RE: CONCEPTUAL DRAINAGE PLAN FOR WESTVIEW BUSINESS PARK
(J-11/D1A) RECEIVED AUGUST 29, 1986

Re: Minato Townhouse/Commercial Development Drainage Report

SUBJECT: MINATO TOWNHOUSE & COMMERCIAL DEVELOPMENT DRAINAGE REPORT

DRAINAGE REPORT
FOR
MINATO TOWNHOUSE
AND
COMMERCIAL DEVELOPMENT

TITLE: CONCEPTUAL GRADING & DRAINAGE PLAN WEST VIEW BUSINESS PARK					
APPROVALS			APPROVALS		
CITY ENGR.	ENGINEER	DATE	CITY ENGR.	ENGINEER	DATE
A.C.E. DESIGN					
A.C.E. HYD.					
A.M.A.F.C.A.					
DRAWING NO	MAP NO		SHEET		OF
	J - 11		1		2

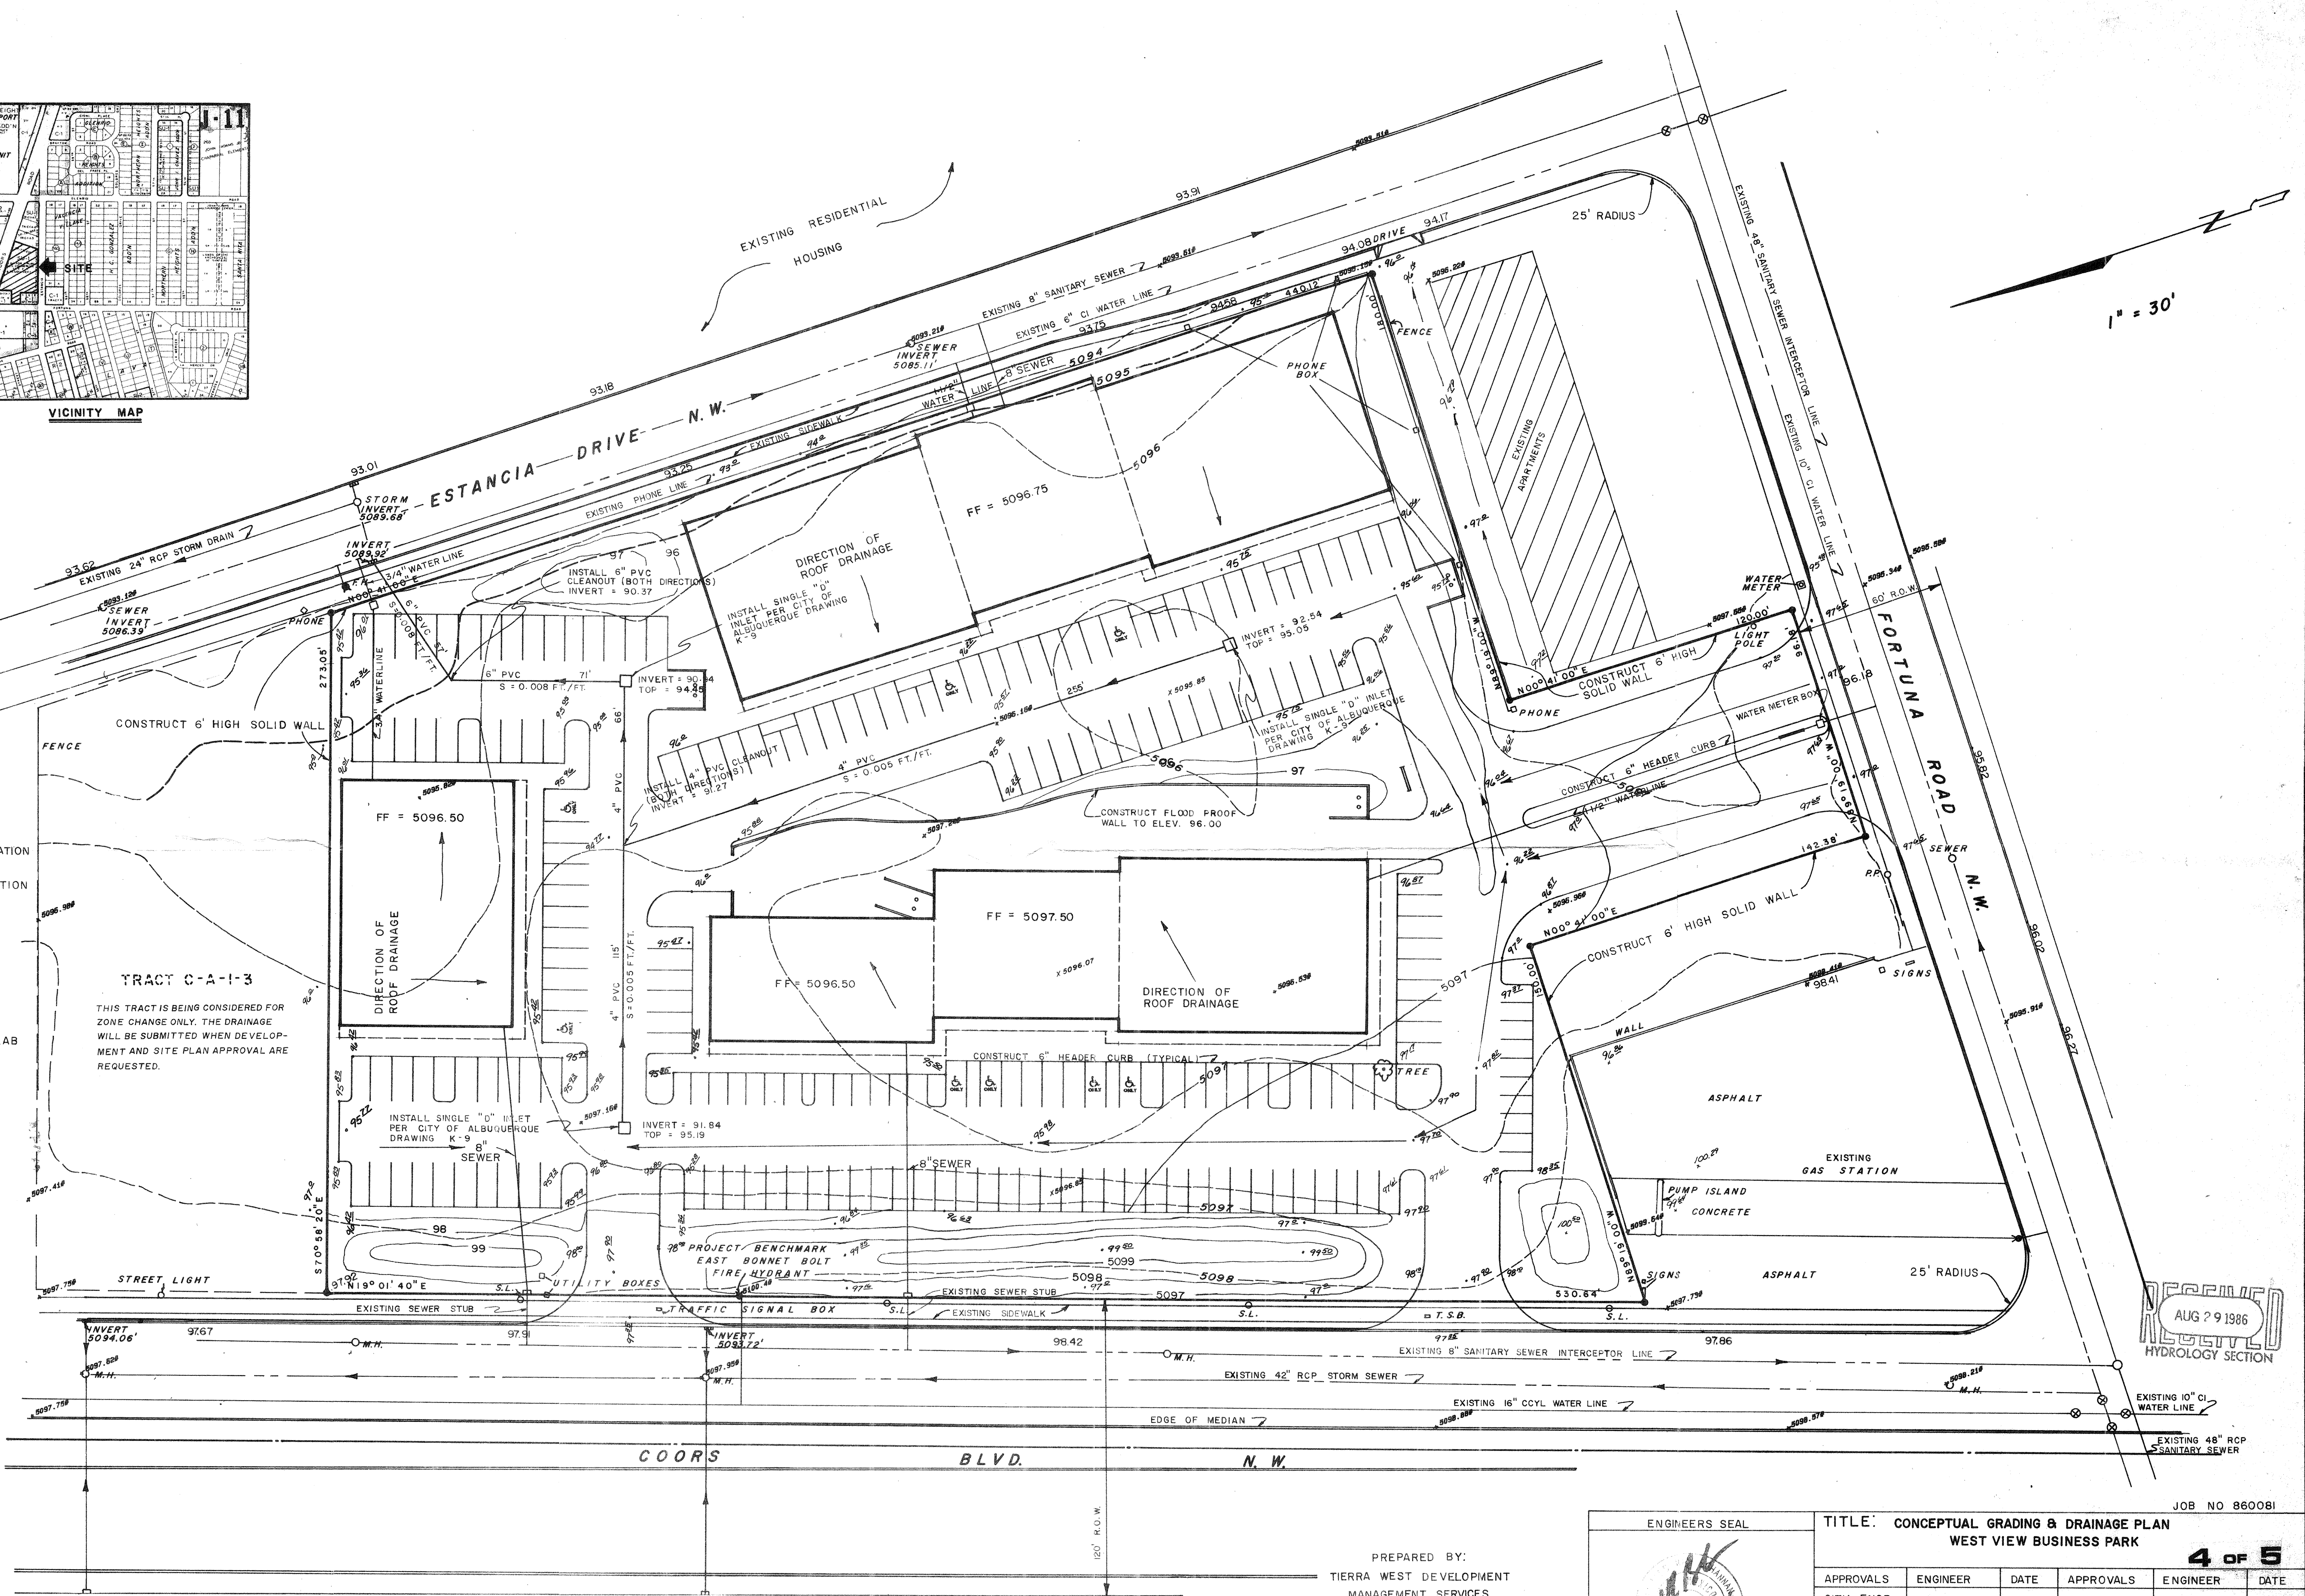
Please review the use of 4 inch PVC pipes for storm drainage. The slopes and size of the pipe could lead to maintenance problems. The tie-in to the catch basin will require a S.O. #19 at Building Permit process.
